CORRECTION TO SERVICE MANUAL

No. SI-A38015
Date. Dec. 14, 1983

MODEL: SX-8

PAGE: 24, 29 (Q213)

P. 24

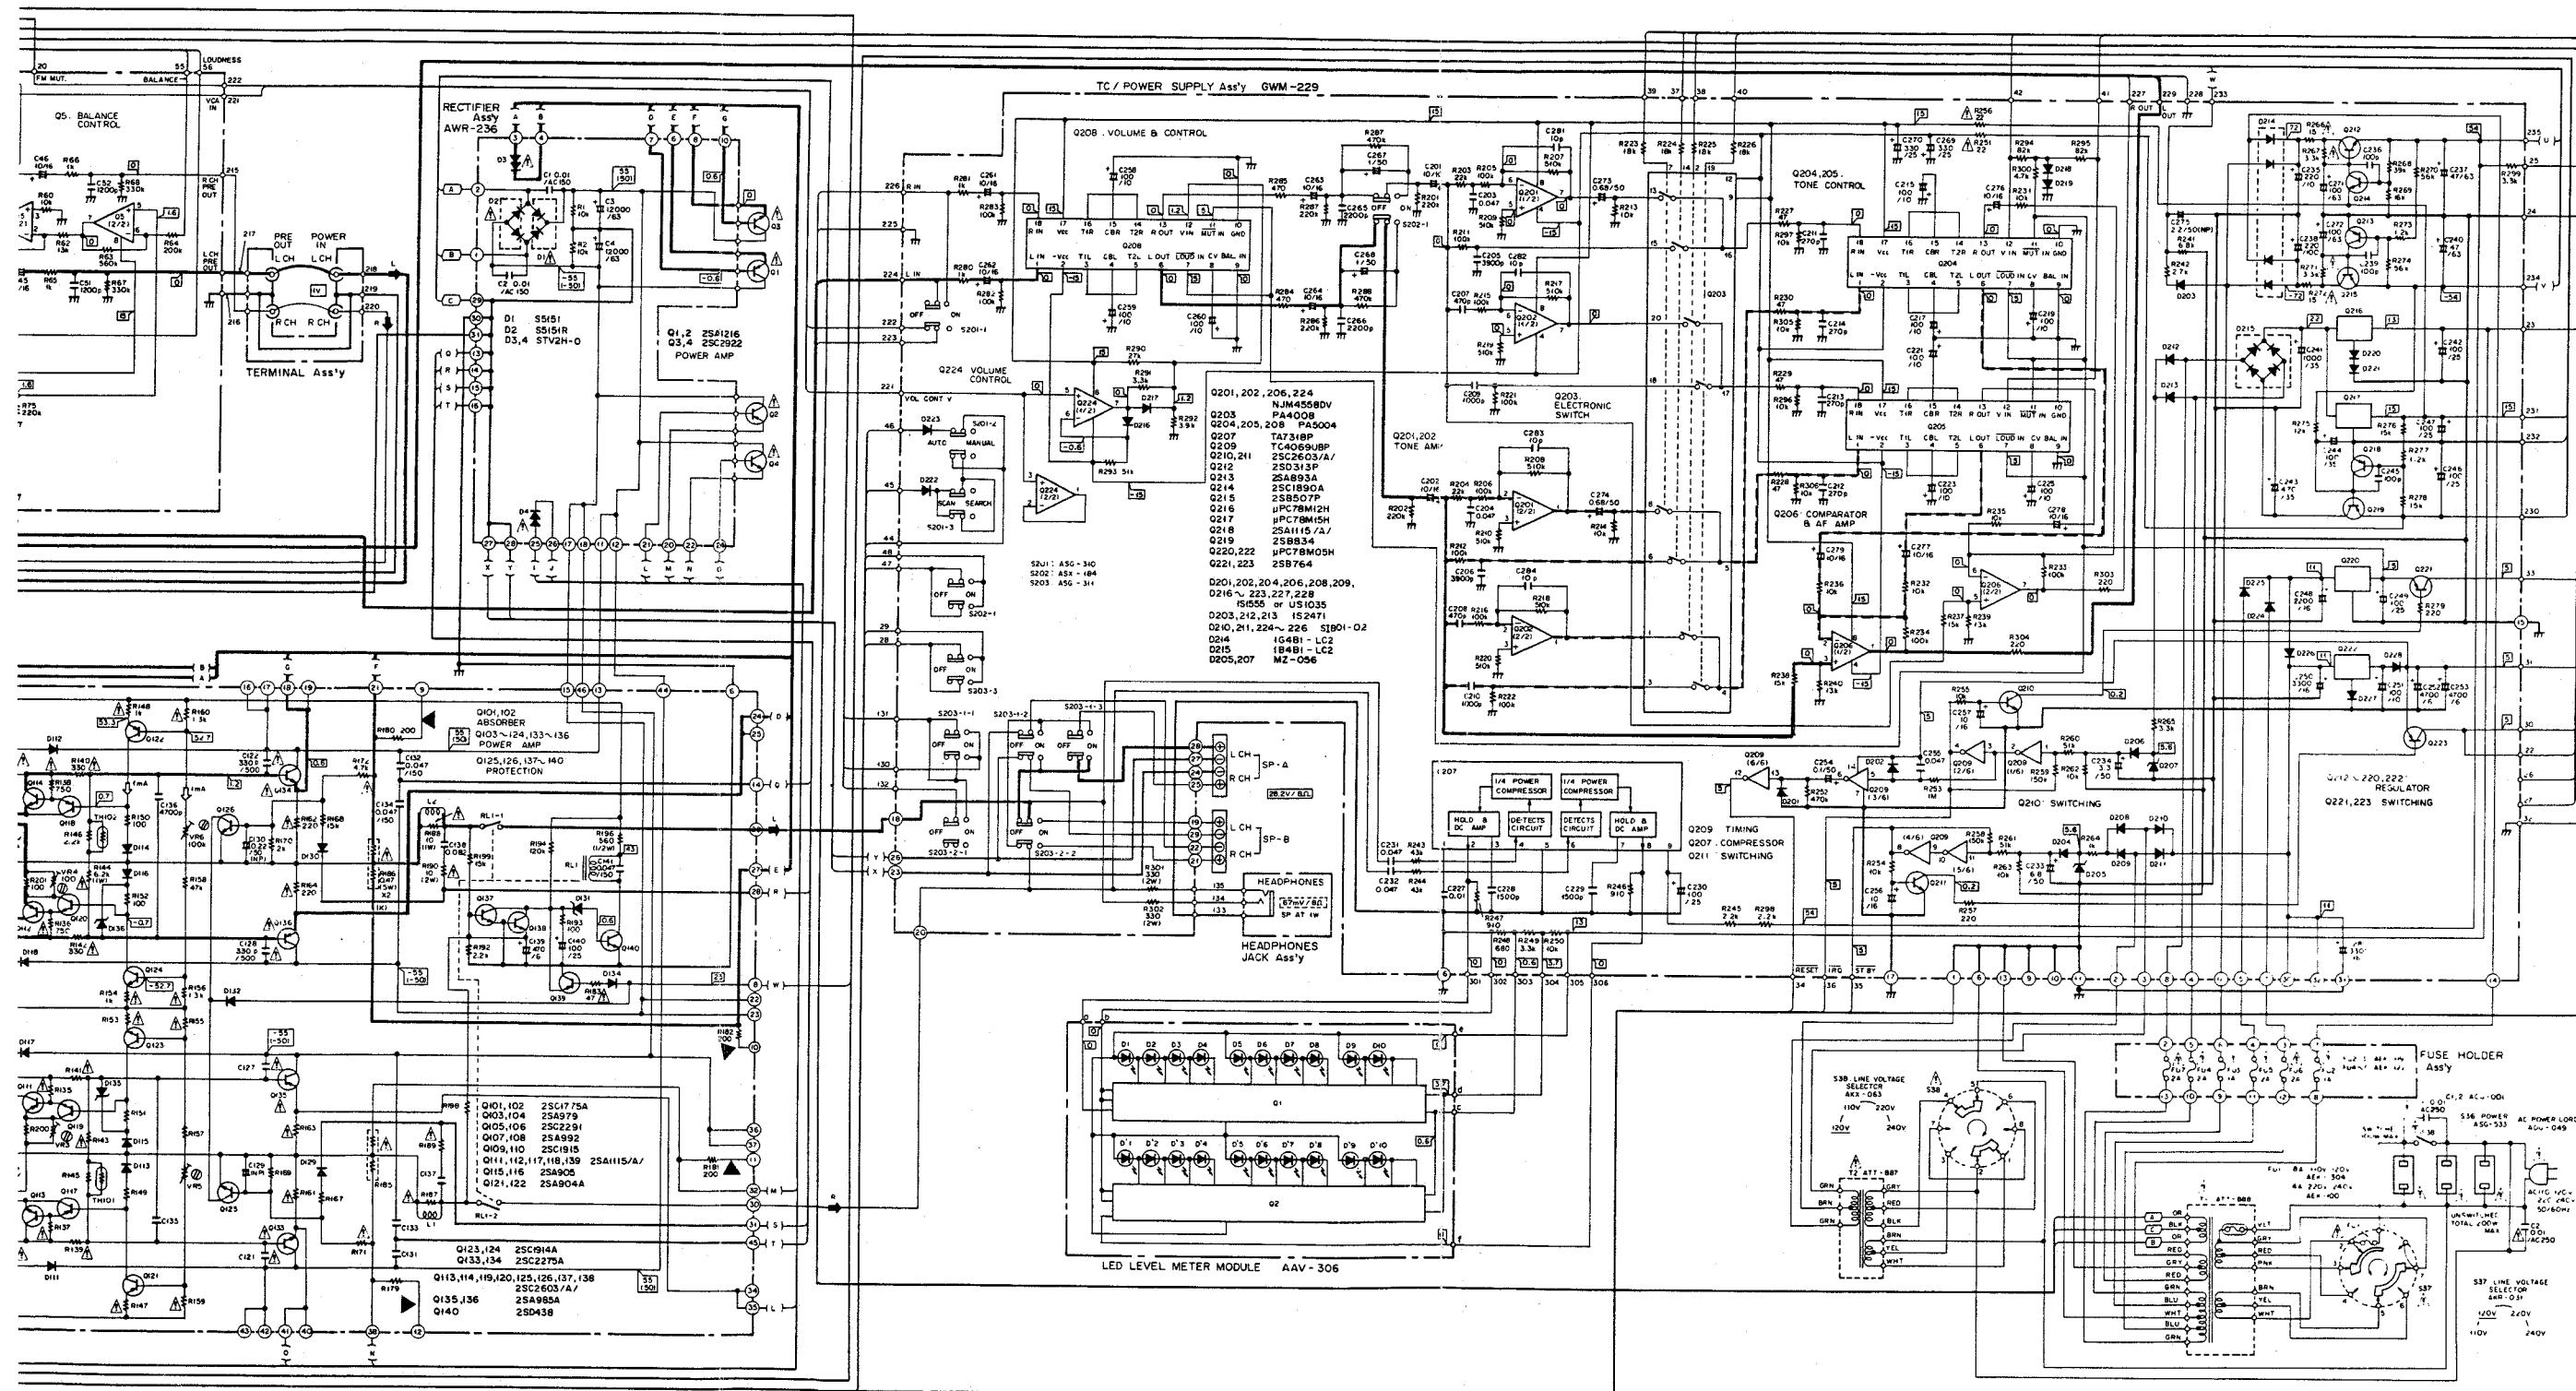
Please correct Service Manual as follows:

ORIGINAL

2SA839A

CORRECTION

2SA893A
